Energy Division

California Public Utilities Commission

Re: Comments of the California Efficiency + Demand Management Council on Draft Resolution E-5150 which Adopts Updates to the Avoided Cost Calculator for Use in Demand-Side Distributed Energy Resource Cost-Effectiveness Analyses

Figure 1: Residential HVAC Savings Load Shape (Summer, Shoulder, and Winter)

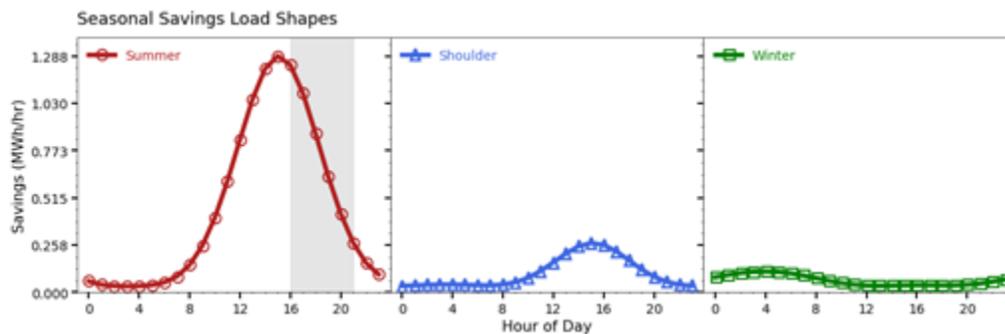
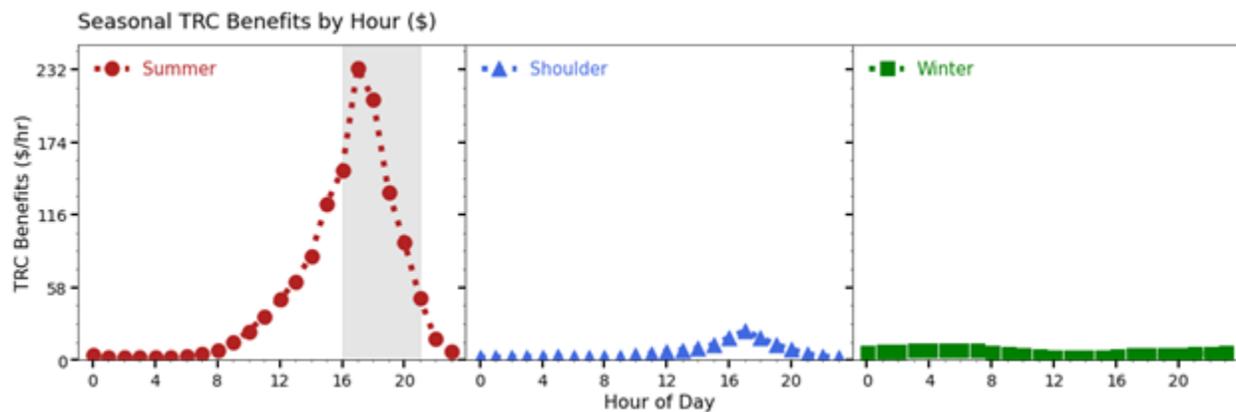
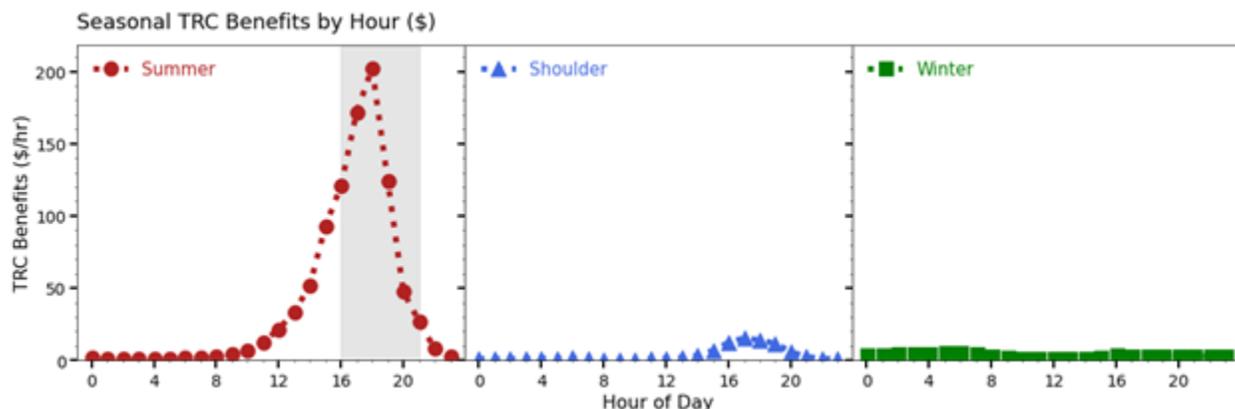
The TRC and PAC calculated with the 2021 ACC are 27% lower with electric avoided costs down 31% and gas avoided costs down 21%. In addition, Figures 1-3 illustrate the 2020 vs. 2021 comparison for this residential HVAC example.

The 2020 avoided cost profile (top) has a higher and broader peak compared to 2021 (note the y-axis ranges differ for 2020 vs. 2021). This example clearly demonstrates that the proposed “minor” changes to the ACC would have a major impact on cost-effectiveness of DERs.

Figure 5: Solar & Battery Storage Resources in No New DER Cases

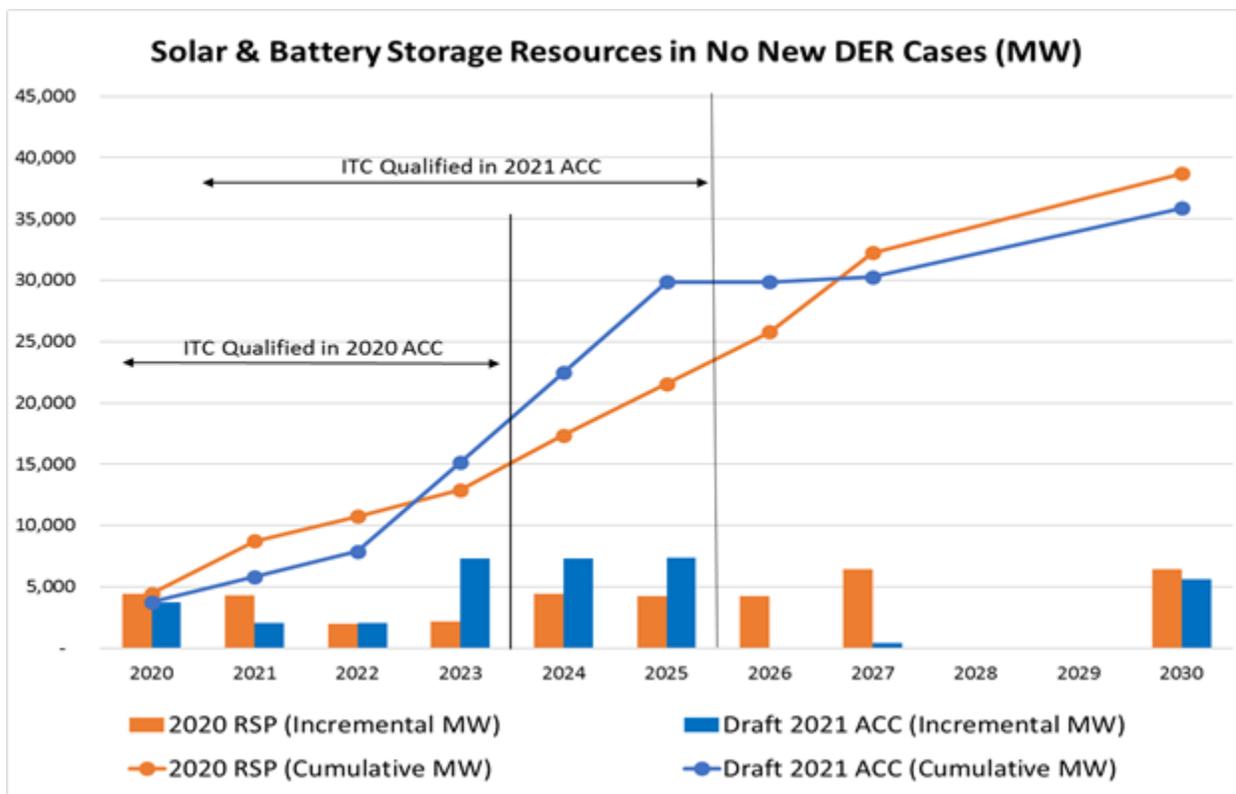
Figure 5 below compares the solar and storage build-outs in the 2020 and draft 2021 ACCs, showing that the draft 2021 ACC assumes that almost 85% of the solar and storage needed in 2030 – a full 30 GW – is installed in the next four years, by 2025, compared to 33% in the 2020 ACC.¹³ This 30 GW includes 18 GW of solar and 12 GW of storage. This change in the timing of solar and storage may account for much of the reduction in the 2030 GHG Adder and in the value of DERs in the draft 2021 ACC.

The Council is certainly supportive of expanded utility-scale solar in the state, but it is not realistic to assume that 18 GW of new utility-scale solar – 150% more than the state’s entire existing utility-scale solar fleet – and 12 GW of new storage – perhaps ten times the existing battery storage capacity – could be built in California in the next four years.
